REVISED RESPONSE TO REQUEST FOR ADDITIONAL INFORMATION

APR1400 Design Certification

Docket No. 52-046

RAI No.: 13-7856
SRP Section: 12.02 – Radiation Sources
Application Section: 12.2
Date of RAI Issued: 05/22/2015

Figure 1. Shielding and Layout of Holdup Tank

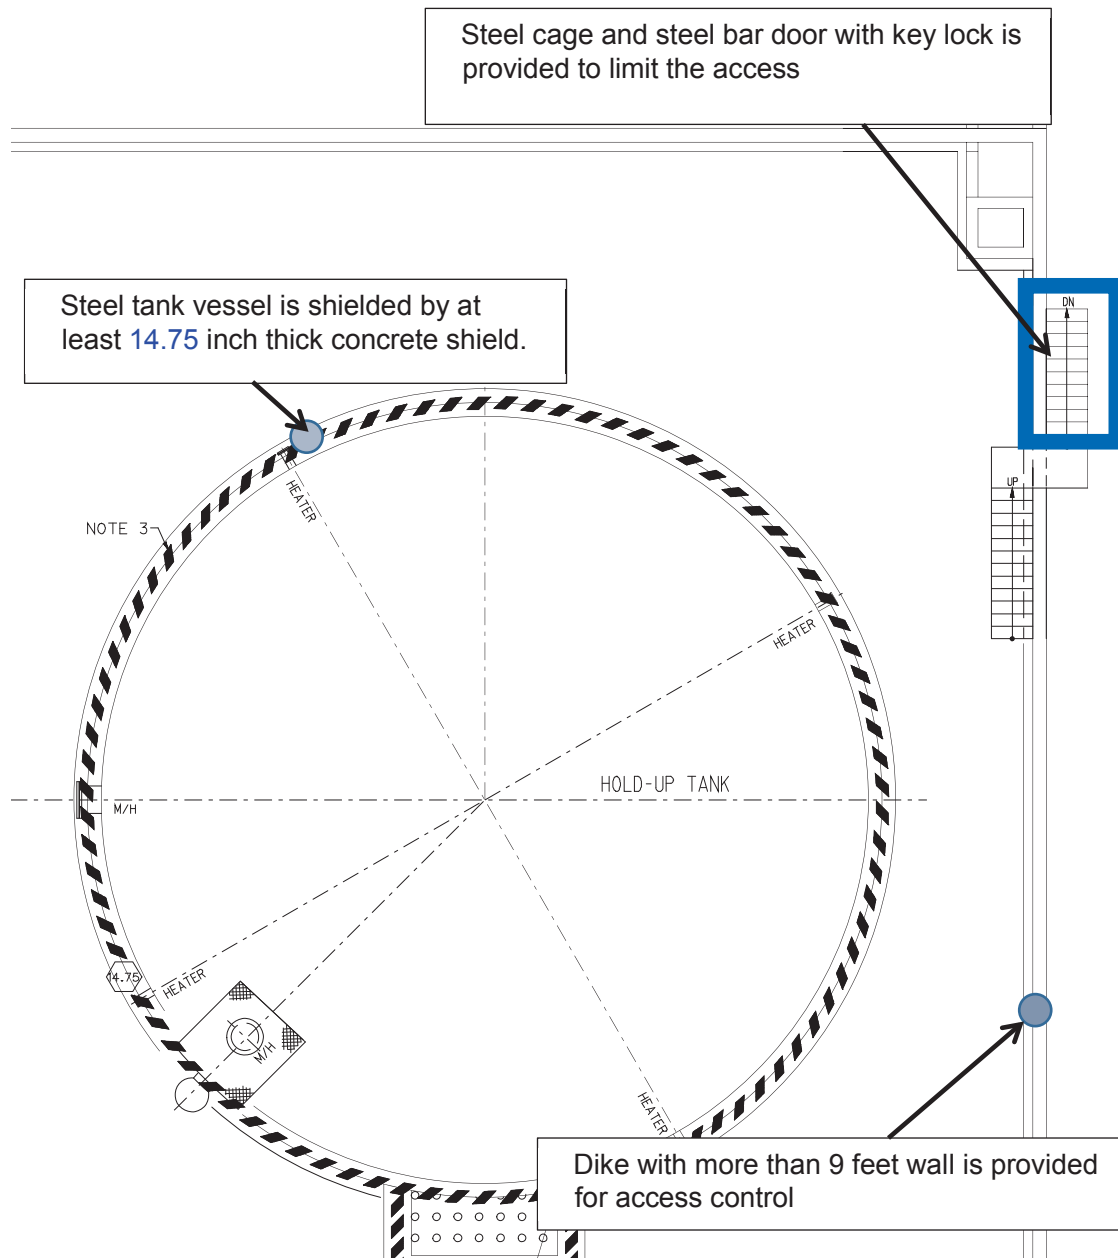
4. FSAR Section 12.2.1.6 indicates that the surface dose rate of these tanks will not exceed 2.5 micro Sieverts per hour. While staff cannot perform dose rate calculations without tank dimensions and parameters (as discussed in Question 2, above), the source terms for the holdup tank and BAST provided in FSAR Table 12.2-13, contain

fairly significant quantities of radioactive material. It seems unlikely to staff that the dose on the surface of these tanks would not exceed 2.5 micro Sieverts per hour using the 0.25% failed fuel percentage source term provided in Table 12.2-13. Please provide an analysis that shows the dose rate on the surface of these tanks will not exceed 2.5 micro Sieverts per hour on the surface of these tanks using the 0.25% failed fuel percentage source term provided in FSAR Table 12.2-13. If not, please modify FSAR Section 12.2.1.6 accordingly and provide the radiation zoning for these areas.

- b. As presented in Figure 1, the holdup tank itself is composed of a steel vessel with a minimum 14.75-inch thick concrete shield wall outside the vessel to ensure that the dose rate outside the tank is less than 2.5 $\mu\text{Sv/hr}$. This design feature is also applicable to the BAST. The RWMT is not shielded with concrete since the design basis dose rate outside the vessel is low enough to maintain the dose rate below 2.5 $\mu\text{Sv/hr}$ without the concrete shield wall.

4. The Holdup Tank and the BAST are stainless steel tanks with a layer of concrete shield wall surrounding the tank, from bottom to top, with no gap between the tank surface and concrete wall. The thickness of the concrete layer is provided in Table 1 below for convenience. These and other parameters are added to Table 12.2-25 (Please refer to response to Issue #2 above). Please also note that other design features of the tanks are discussed in response to Issue #3 above.
